### ADDENDUM NO. 2 November 14, 2023

### Burnet City Hall – RFP 2023-012 PID: CIPSP-2022B

This Addendum forms a part of the Contract and clarifies, corrects or modifies the original Construction Documents, plans dated <u>9/15/2023</u>. Acknowledge receipt of this addendum in space provided on Proposal. Failure to do so may subject bidder to disqualification.

14 Nov 2023 | 13:24:50

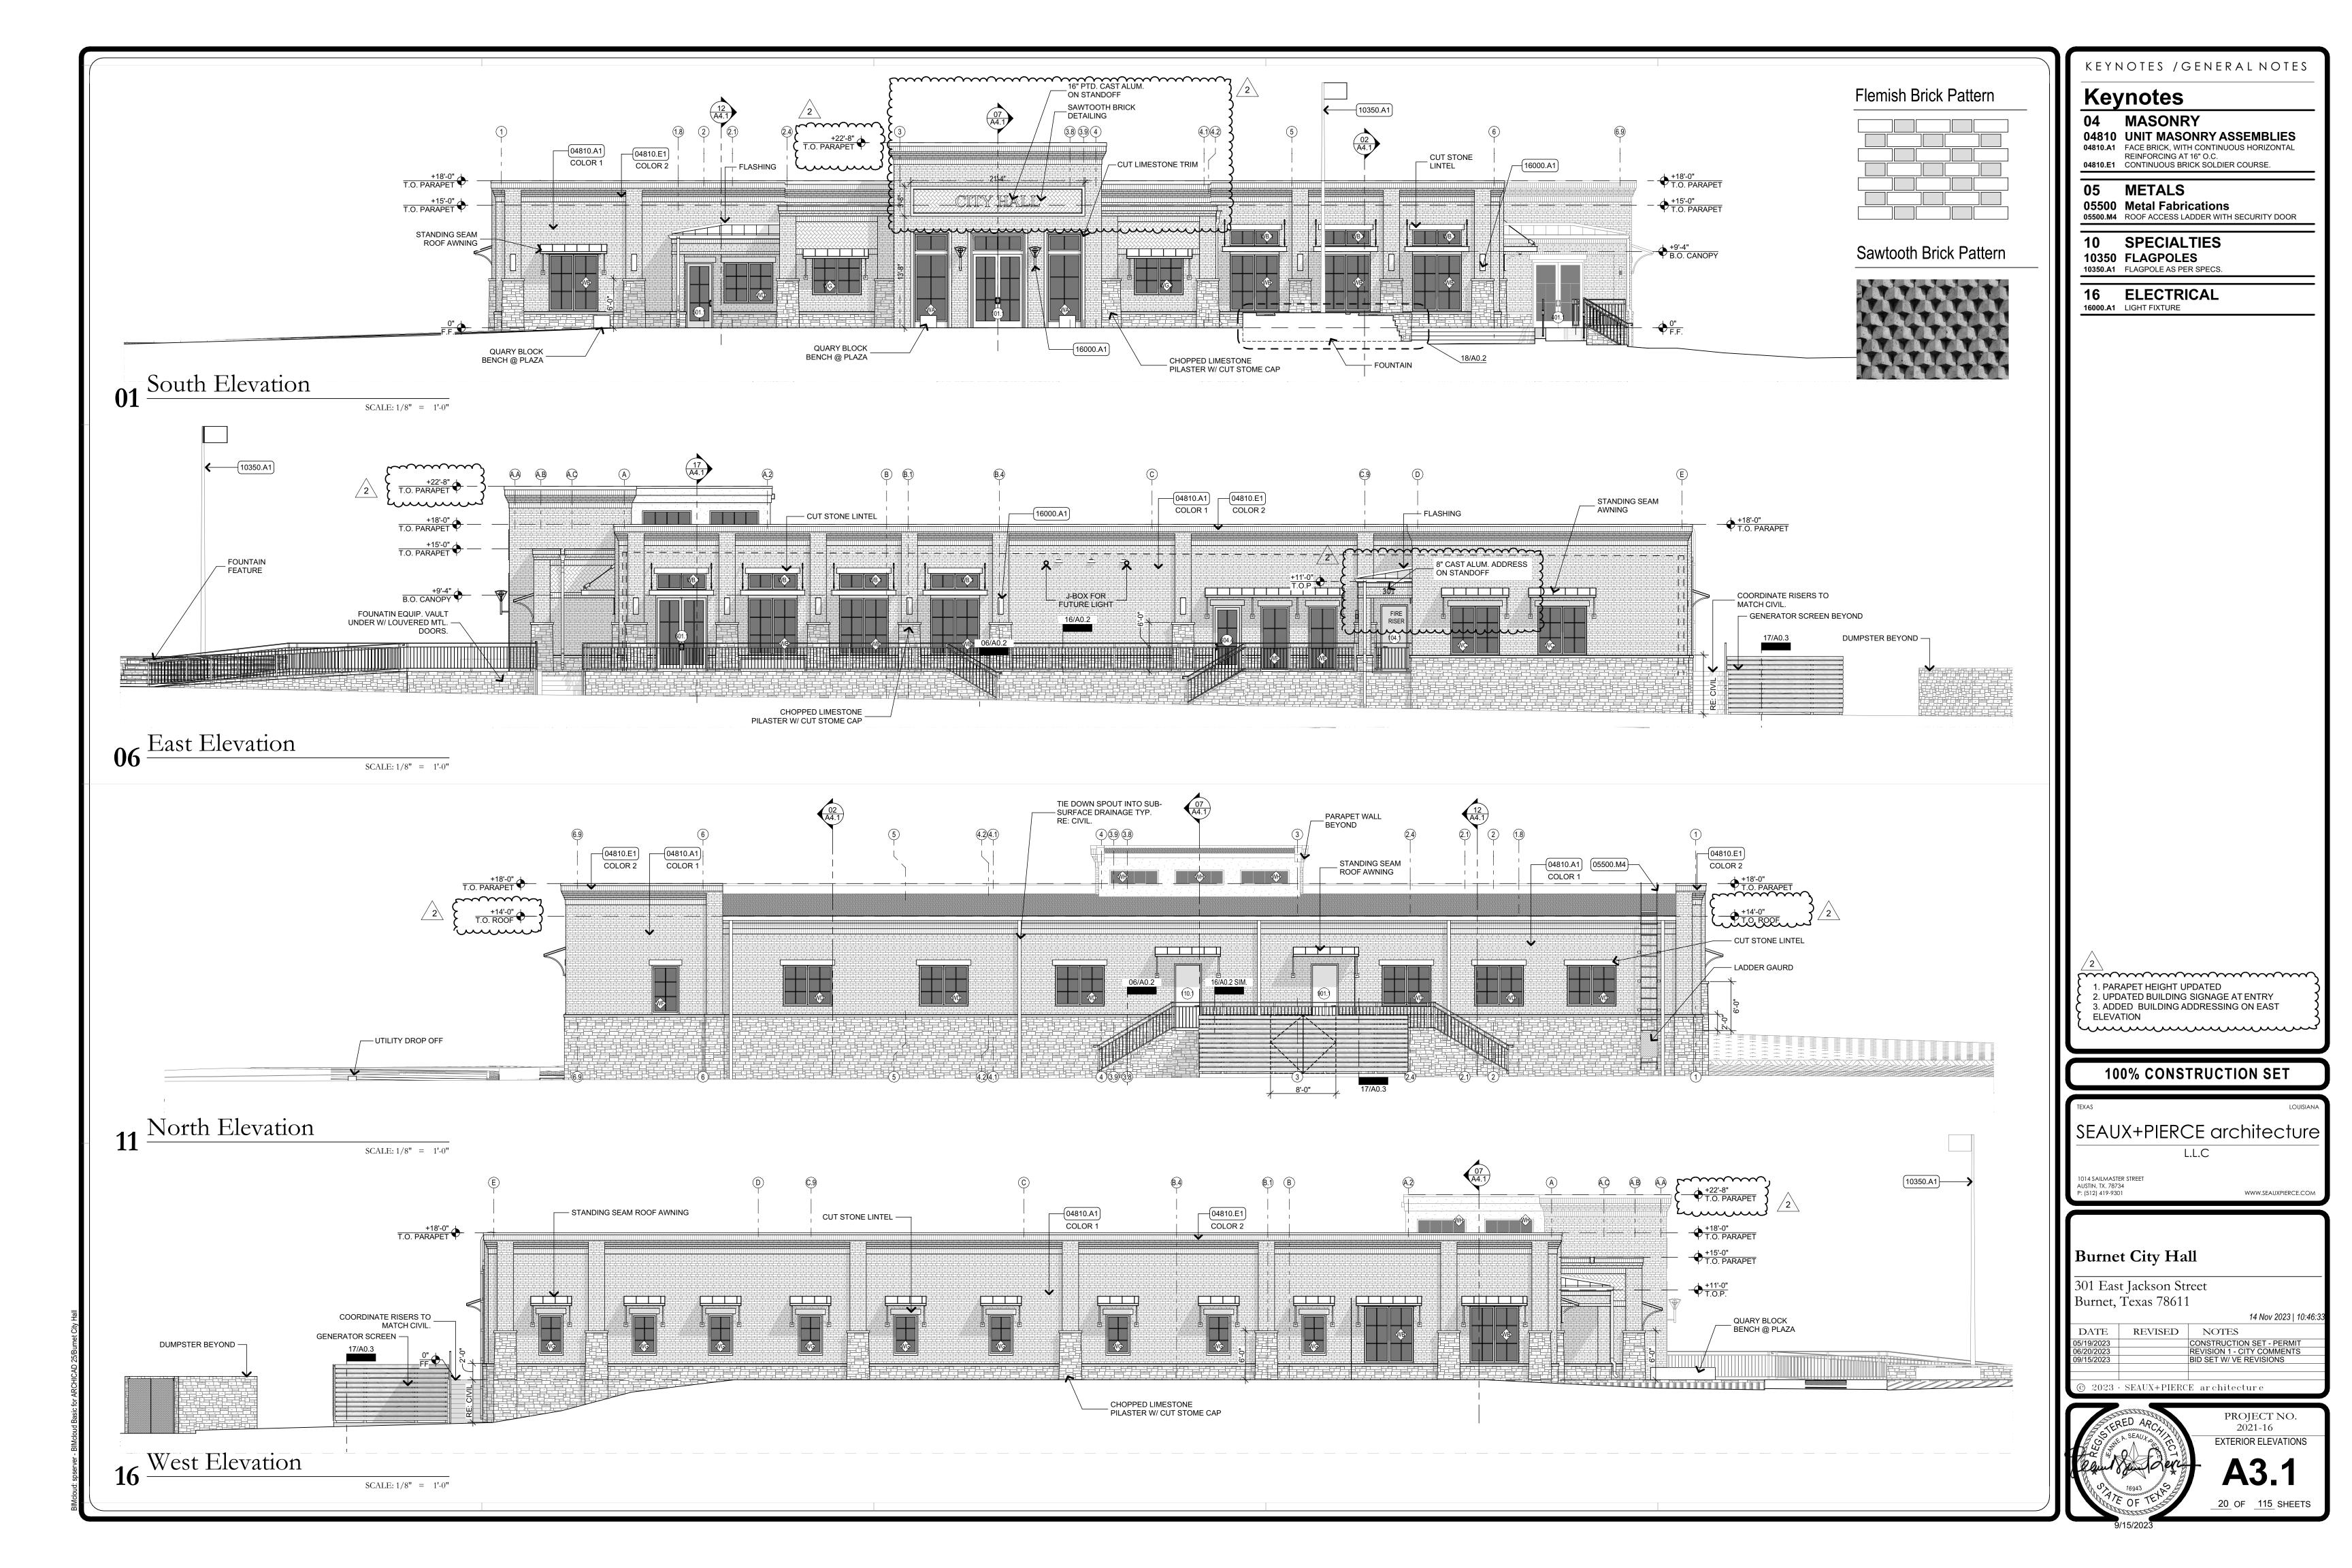
- 7. Sheet A1.4 (Window Schedule)
  - a. Changed size of window type WH and adjusted head height.
- 8. Sheet A2.3 (Roof Plan)
  - a. Changed roofing to PVC Membrane system.

FOUNDATION PLAN

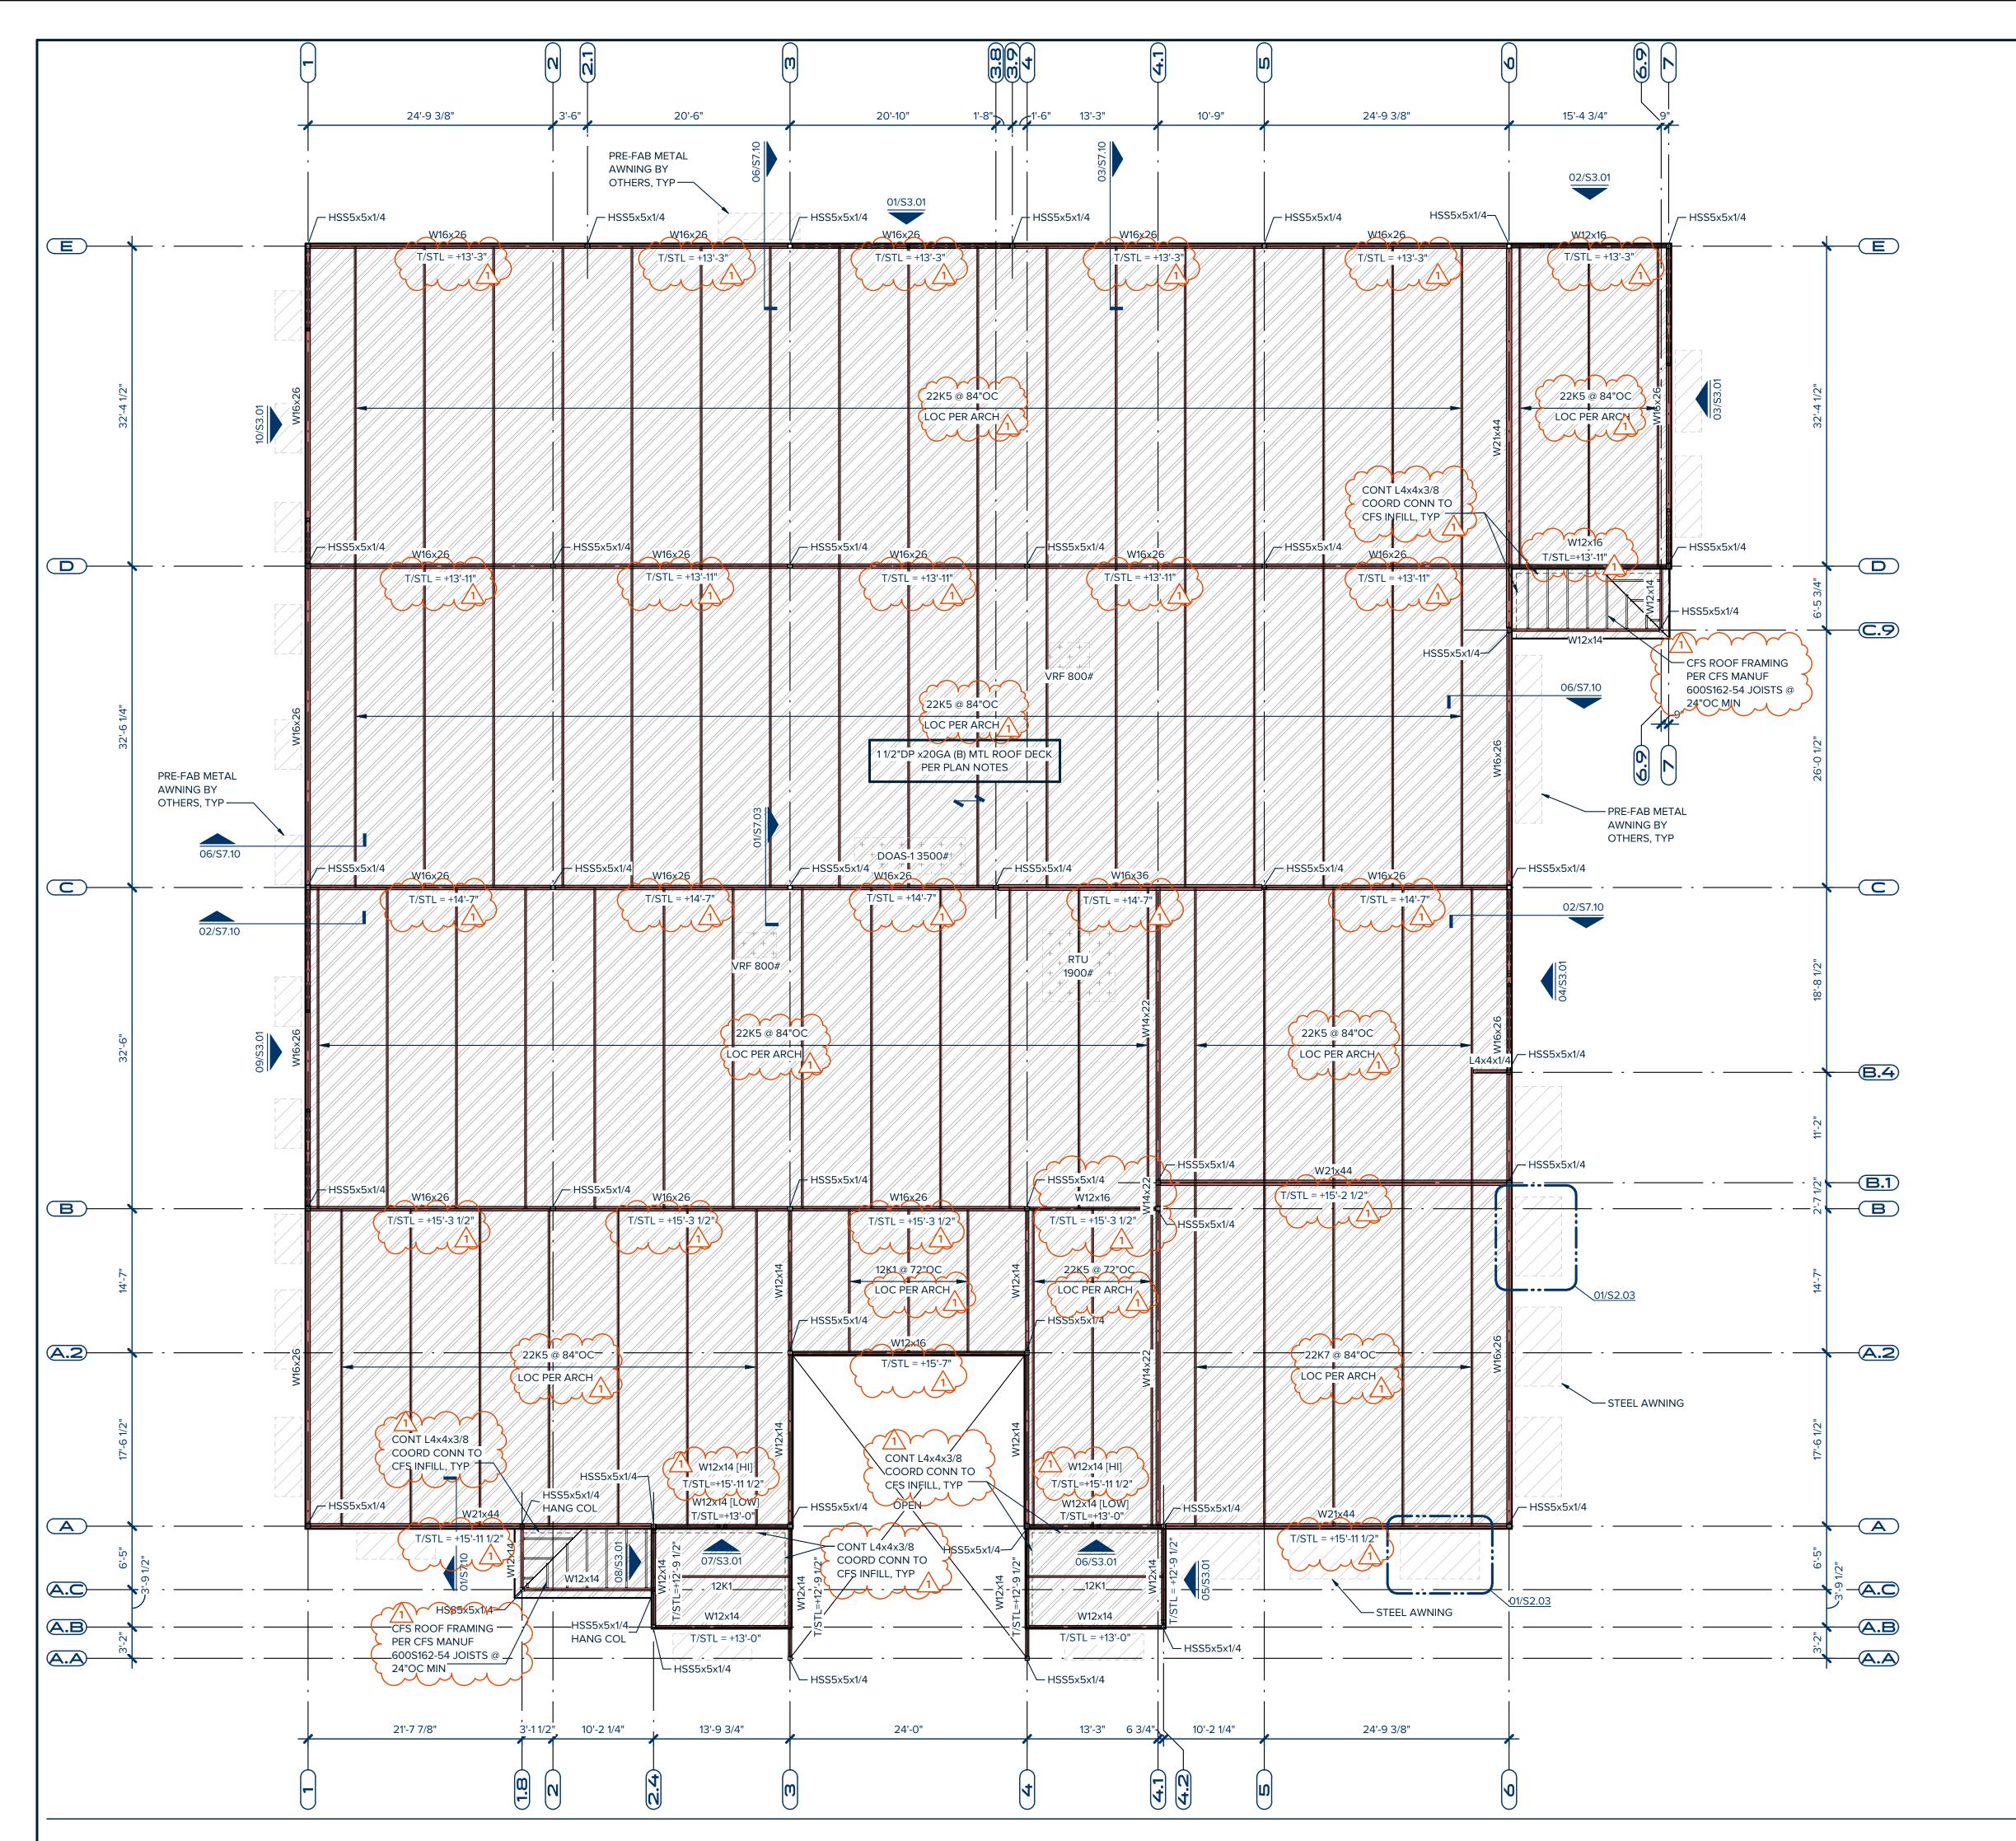
- 18. Sheet S2.01 (Foundation Plan)
  - a. Adjusted the brick lug from 5-1/2" to 7-1/2" to support stone wainscot.
  - b. Added dimension to pilasters.
- 19. Sheet S2.02 (Roof Framing Plan)
  - a. Adjusted Top of Steel to accommodate 1/4" roof slope.
  - b. Added missing steel lintels.
  - c. Added notes for roof framing at porch roofs.
- 20. Sheet S2.03 (High Roof Framing Plan)
  - a. Adjusted Top of Steel to accommodate 1/4" roof slope.
- 21. Sheet S3.01 (Braced Frame Elevations)
  - a. Adjusted to accommodate roof pitch.
- 22. Sheet S4.10 (Foundation Details)
  - a. Revised brick lug dimensions.
